## KUNDENDIENSTMITTEILUNG

Datum May 1968

Brake cam with hexagon

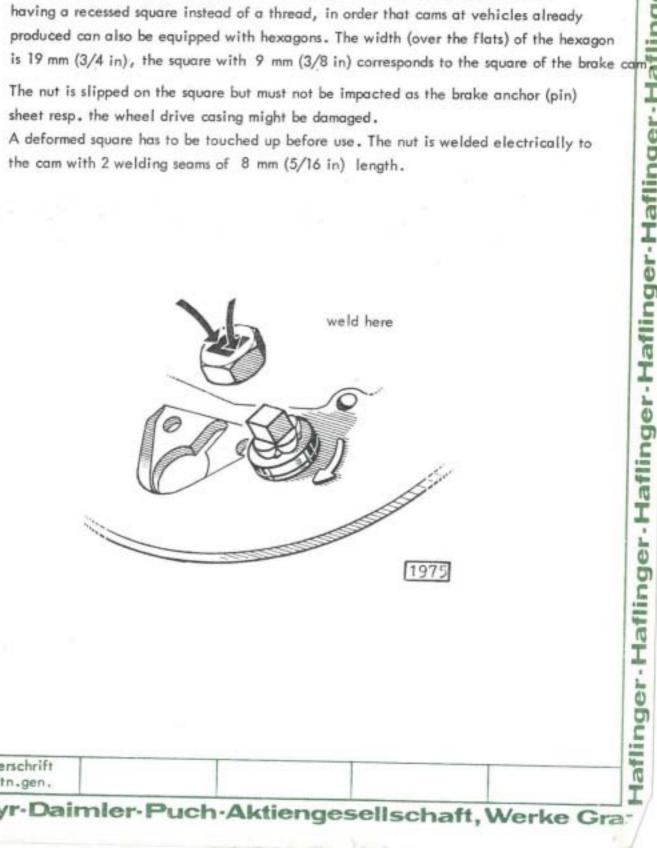
In order to enable easier adjustment of the brake the square of the brake cam is replaced by a hexagon screw of 19 mm (3/4 in) width.

From April 1967 all vehicles will be equipped with these new brake cams.

Our spare parts department will supply a hexagon nut Part no. 700.1.34.027.1 having a recessed square instead of a thread, in order that cams at vehicles already produced can also be equipped with hexagons. The width (over the flats) of the hexagon
